From: Kimberly.Reinhart@snwa.com
Sent: Tuesday, October 11, 2011 2:18 PM
To: BLM_NV_NVSO_GWProjects
Cc: lisa.luptowitz@snwa.com; zane.marshall@snwa.com; john.entsminger@lvvwd.com
Subject: SNWA's GWD Project DEIS Comments
Attachments: SNWA_GWD Project DEIS Comment Letter_with_Errata_10-11-11.pdf

SUBJECT: CLARK, LINCOLN, AND WHITE PINE COUNTIES GROUNDWATER DEVELOPMENT PROJECT DRAFT ENVIRONMENTAL IMPACT STATEMENT COMMENTS

This letter provides the Southern Nevada Water Authority's (SNWA) formal public comments on the Clark, Lincoln, and White Pine Counties Groundwater Development Project (GWD Project) Draft Environmental Impact Statement (DEIS) and Draft Section 106 Programmatic Agreement. As the right-of-way (ROW) applicant, SNWA conducted a comprehensive review of the DEIS. SNWA provides comments on the following issues to provide additional information and perspective: (1) SNWA's continuing need for the GWD Project; (2) development of the groundwater model; (3) purpose of the programmatic National Environmental Policy Act (NEPA) analysis; and (4) the monitoring, mitigation, and management plan for Snake Valley. SNWA requests that this comment letter, attached errata comments, and

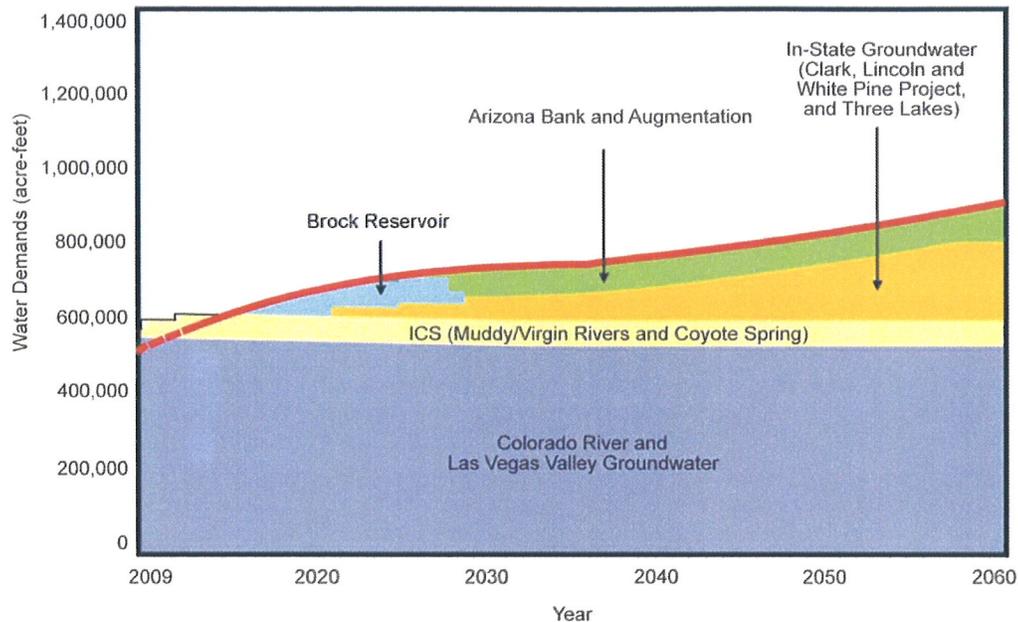
Groups like the Pacific Institute and Water Resource Advocates suggest that SNWA can do even more to reduce demand and that it is possible to meet all of southern Nevada's water

needs through conservation. These opinions, however, are based on erroneous assumptions that disregard pertinent data. For example, in their 2007 report “Hidden Oasis: Water Conservation and Efficiency in Las Vegas,” the Pacific Institute and Water Resource Advocates maintain that southern Nevada could save 12,000 afy by equipping homes with 1.6 gallon per flush toilets, rather than the standard 3.5 gallon per flush toilets. This water savings, however, is inflated because it assumes that every home in Las Vegas currently uses 3.5 gallon per flush toilets, when in fact, since 1994, all new homes in Las Vegas (which accounts for 61% of homes) were equipped with 1.6 gallon per flush, or lower, toilets (SNWA, 2011: *Rebuttal Report of Water Conservation and Efficiency in Southern Nevada, Presentation to the Office of the Nevada State Engineer*, Exhibit SNWA_395, page 3-4).
